HOMWOOD SUITES

3500 S. MERIDIAN

NO.	DATE	DESCRIPTION
07-15-21		CITY COMMENTS
11-05-21		CITY & FRUITLAND MUTUAL WATER COMMENTS

OVERALL SITE PLAN
C-1

STORM UTILITY PLAN
C-4.1

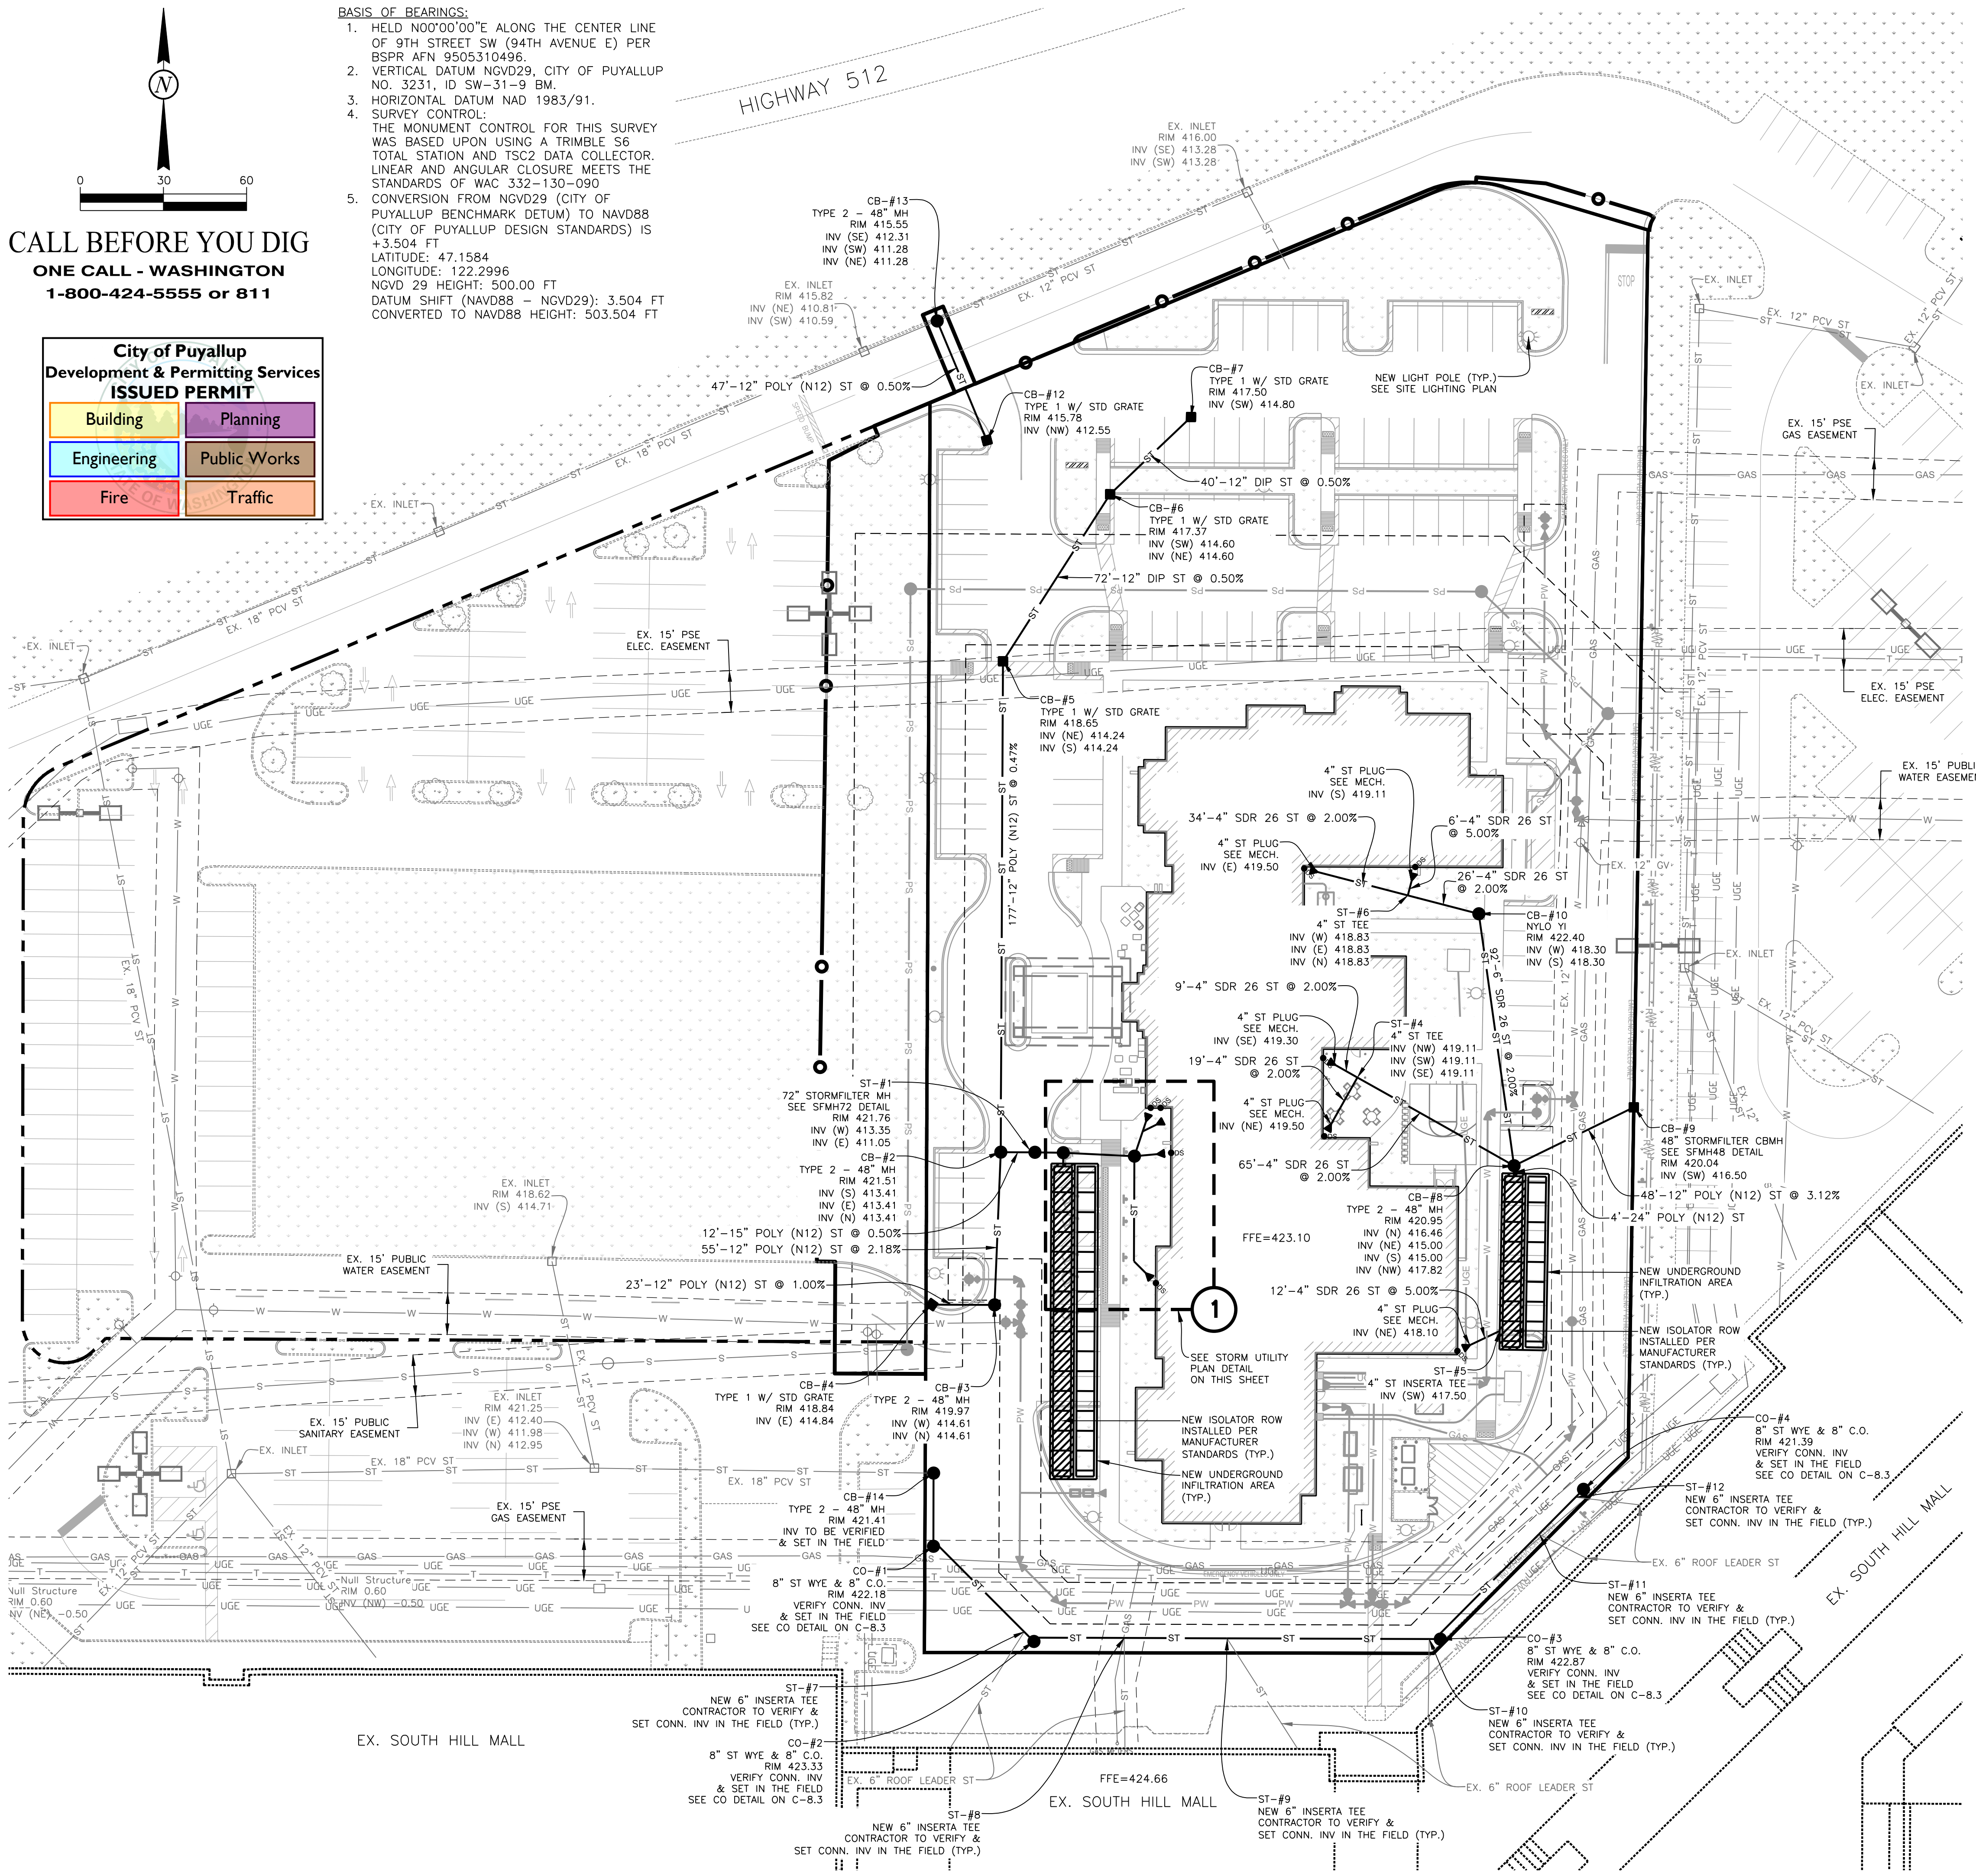
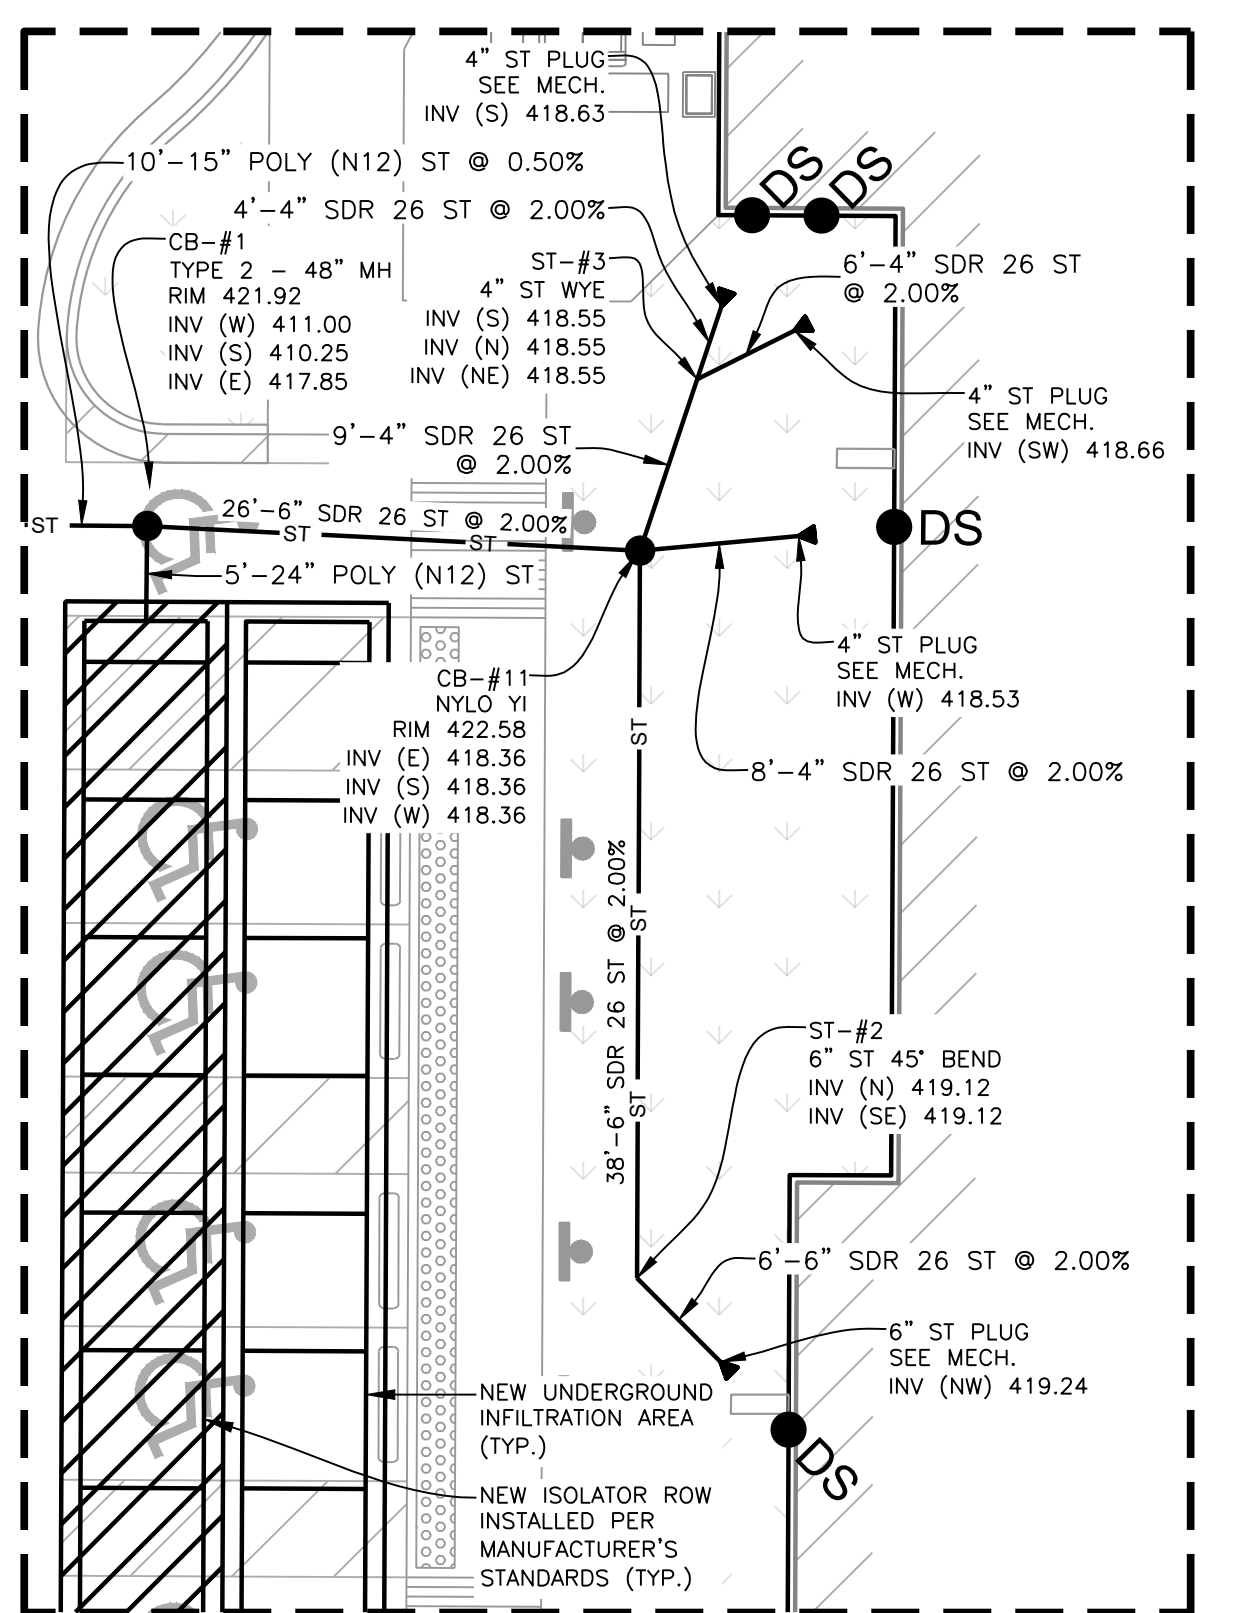
- CITY COMMENTS - 07-13-21**
 - UPDATED STORM UTILITY PLANS TO COORDINATE WITH THE STORMWATER ENGINEER'S DESIGN/CALCULATIONS
 - ADDED CoP APPROVAL STAMP
- CITY & WATER COMMENTS - 11-05-21**
 - UPDATED STORM UTILITY PLANS TO COORDINATE WITH THE STORMWATER ENGINEER'S DESIGN/CALCULATIONS
 - UPDATED THE ESTIMATED STORM QUANTITIES PER THE STORM UPDATES
